NOTICE OF PUBLIC HEARING Centerton Planning Commission

NOTICE IS HEREBY GIVEN that a Public Hearing will be held before the City of Centerton, Arkansas Planning Commission on **February 04, 2025, at 6:00 PM** at the Centerton Municipal Complex, 210 Municipal Dr, Centerton, AR 72719, to hear public comment on the application (PUD24-02) submitted by Sandcreek Engineering on behalf of property owners, SM DDB LLC to amend the open space design on 11.27± acres within Featherston Village, zoned R3-SF (Medium-High Density Single-Family Residential) at the SE/C of Womack Rd and Kimmel Rd which was previously approved as part of a Planned Unit Development (PUD19-02).

RE: Featherston Village PUD Revision

OVERALL SITE PLAN
FEATHERSTON PARK
PARK IMPROVEMENTS
CENTERTON, AR

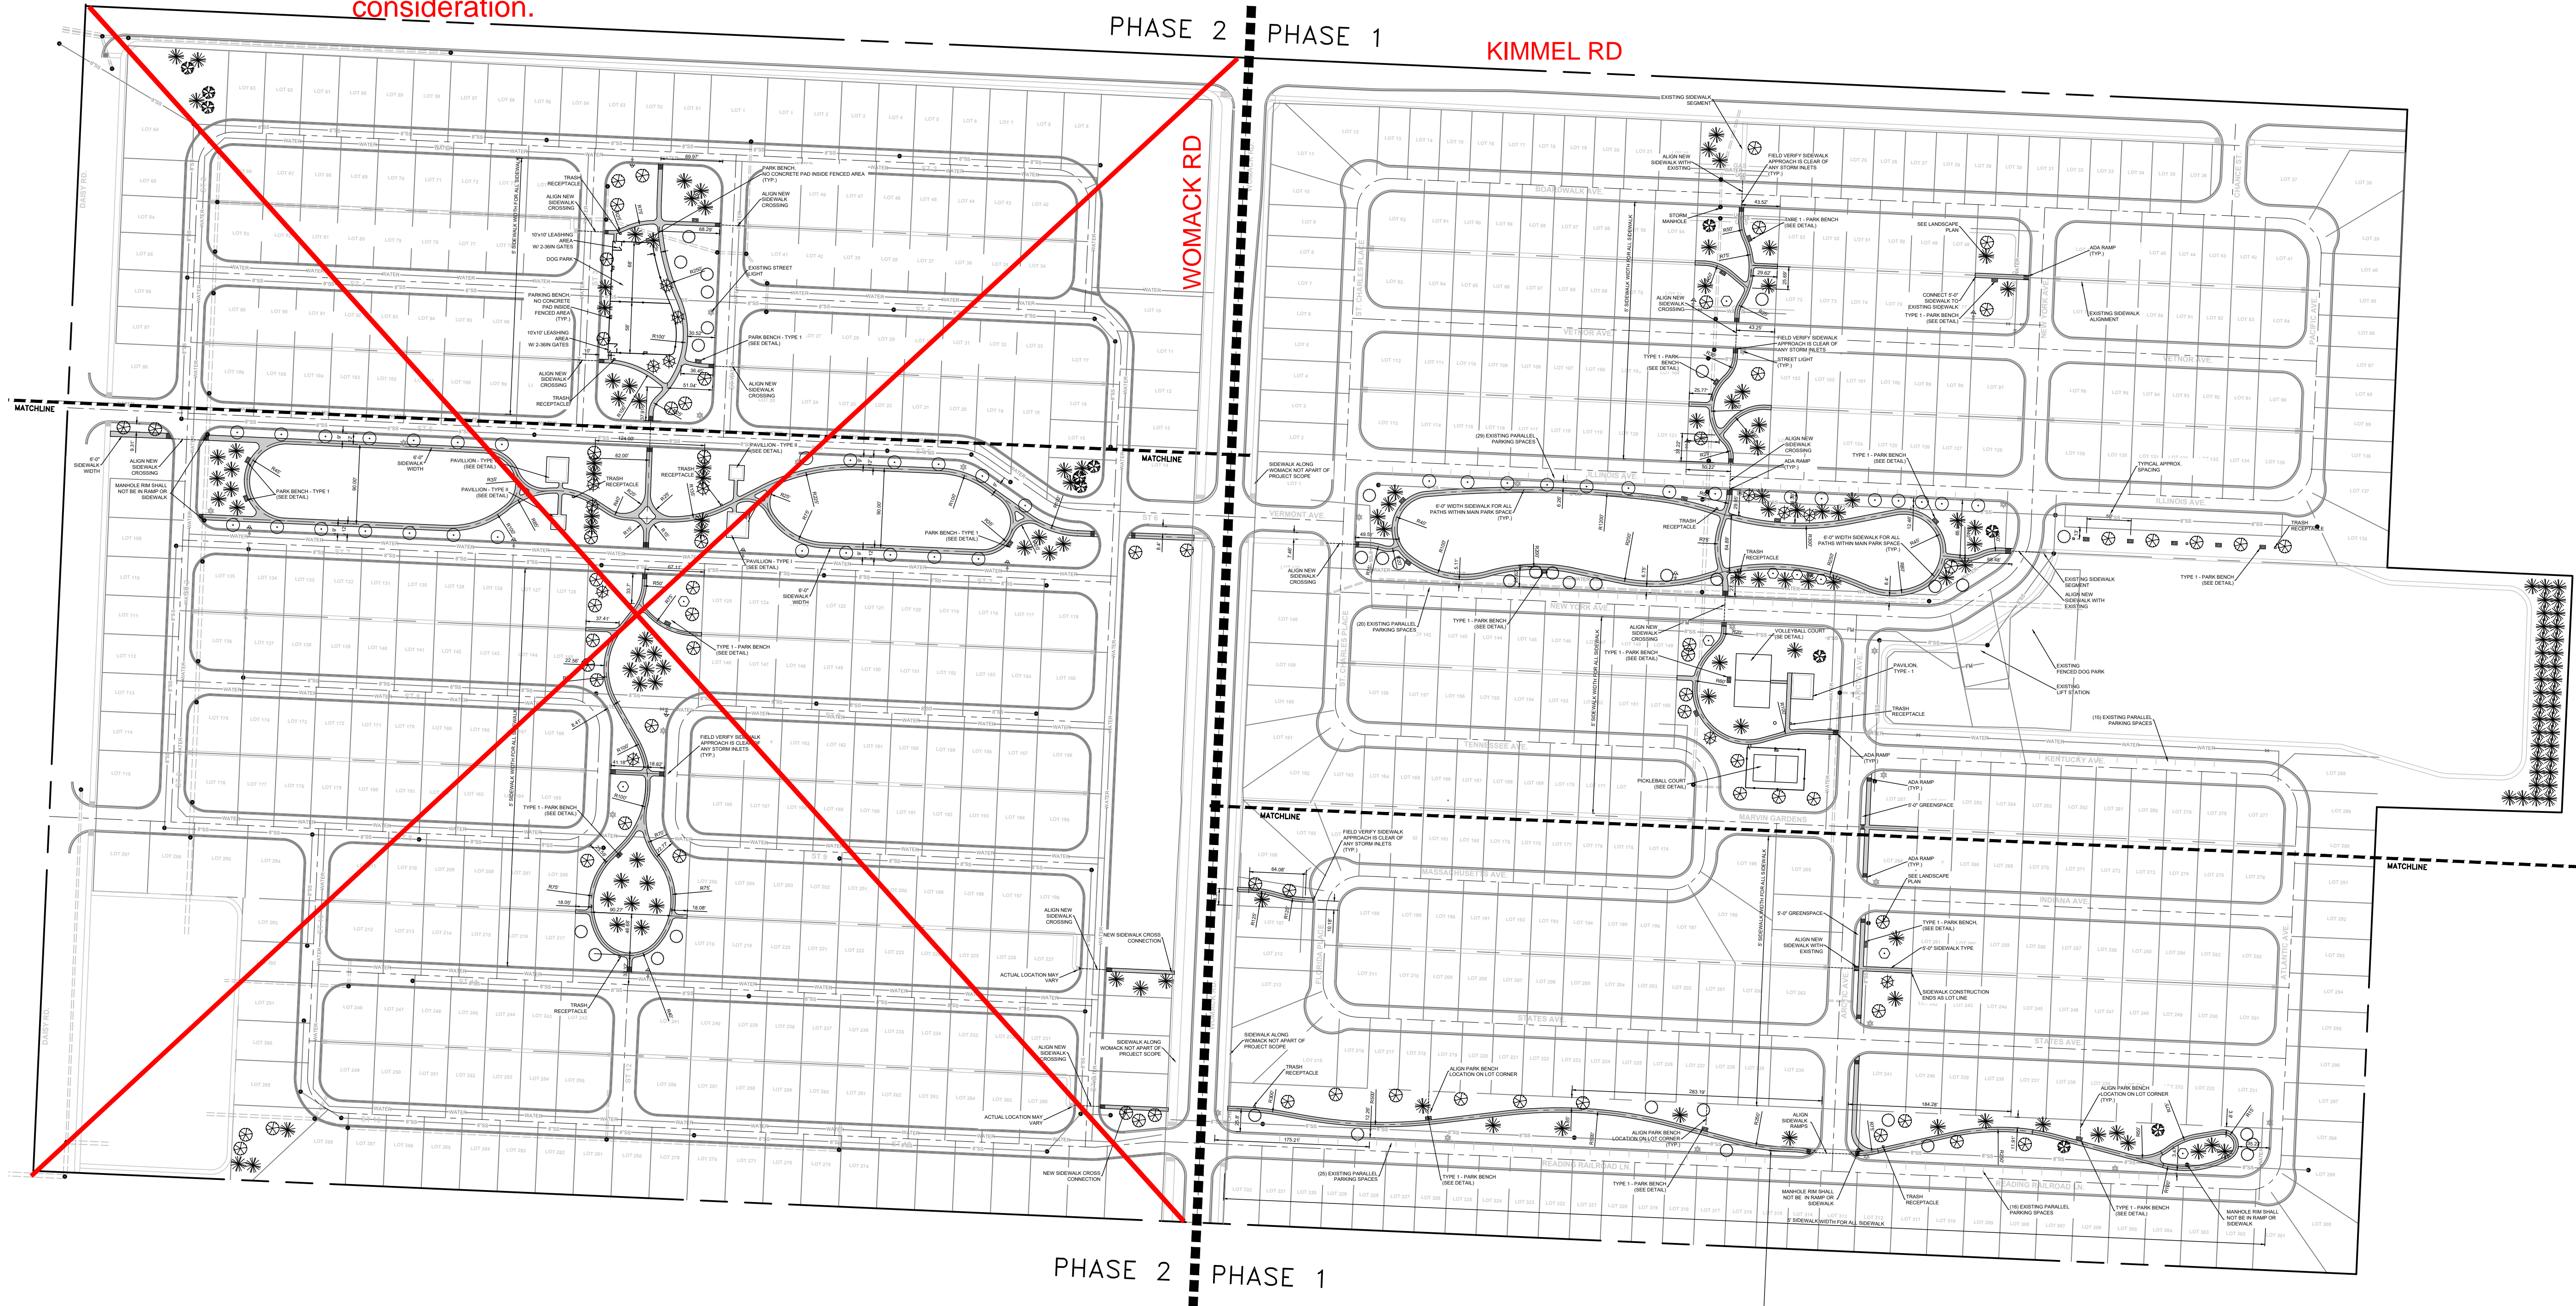
For your consideration, the greenspace and park space has been redesigned to provide an increase in amenities and design elements to the neighborhood. The proposed park space improvements are compliant with the original intent of the PUD by providing greenspace sited for passive enjoyment, activities, and community interaction. The total area of greenspace is unchanged from the original PUD. We have increased the amount of design elements within approved greenspace for the benefit of the community. Below is a summary of the proposed changes.

1. **Park Pavilions:** Custom pavilions are designed for residents to enjoy the views and greenspace. These are sited in various places within the park. The pavilions are adjacent to athletic courts and open space for pedestrian gatherings and rest stops along sidewalks.

2. **Sidewalk/Trails:** Concrete sidewalks have been placed to enhance wayfinding and the exploration of neighborhood park spaces. Instead of a linear traffic pattern, additional sidewalk routes have been provided for looped circulation and connection to amenities. Traffic patterns have been repositioned to create vistas across the central greenspaces throughout the park.

3. **Active Park Amenities:** A sand volleyball and pickleball court provide active residents with an opportunity to gather and enjoy outdoor games. In addition to the existing dog park, a second dog park is in Phase 2 for easy access for all residents.

4. **Plantings:** Trees are an integral part of the greenspace and have been reconfigured to define the park space hierarchy. Trees are used to delineate the large central greenspaces from the smaller parks that are connected via sidewalks. Trees have been employed as wayfinding points in addition to street plantings.
